# **500 Boylston Street Project**

**BRA Final Environmental Impact Report**

February 1985

COMMENT 651/:

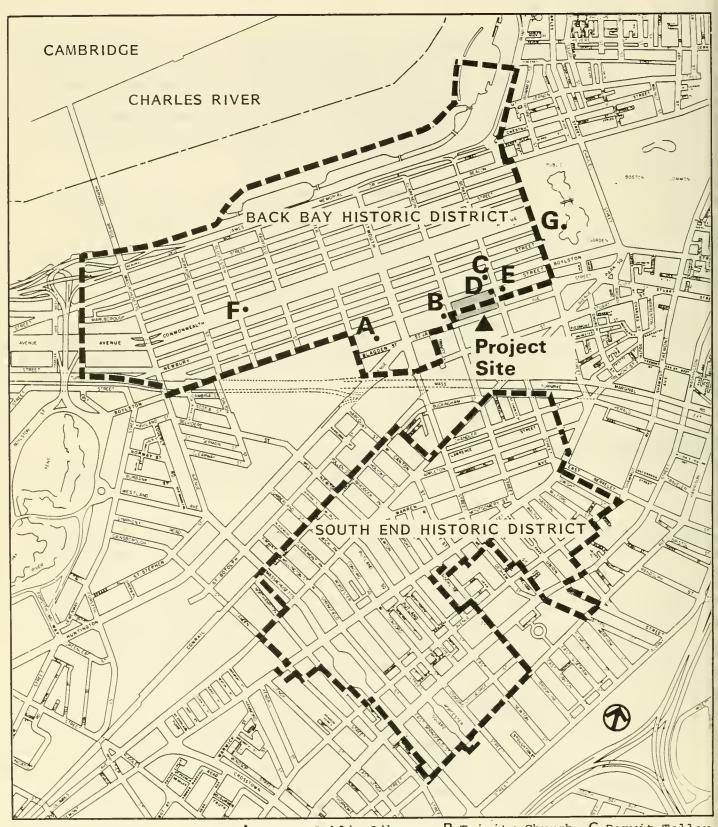
[Ref. Figure IV-29, BRA Draft EIR] The Back Bay and South End historic districts boundaries should be added to the figure (also stated in the text on pg. 154).

The boundaries for the Back Bay and South End Historic Districts have been clarified and the revised figure is presented in this BRA Final EIR as Exhibit IV-11.
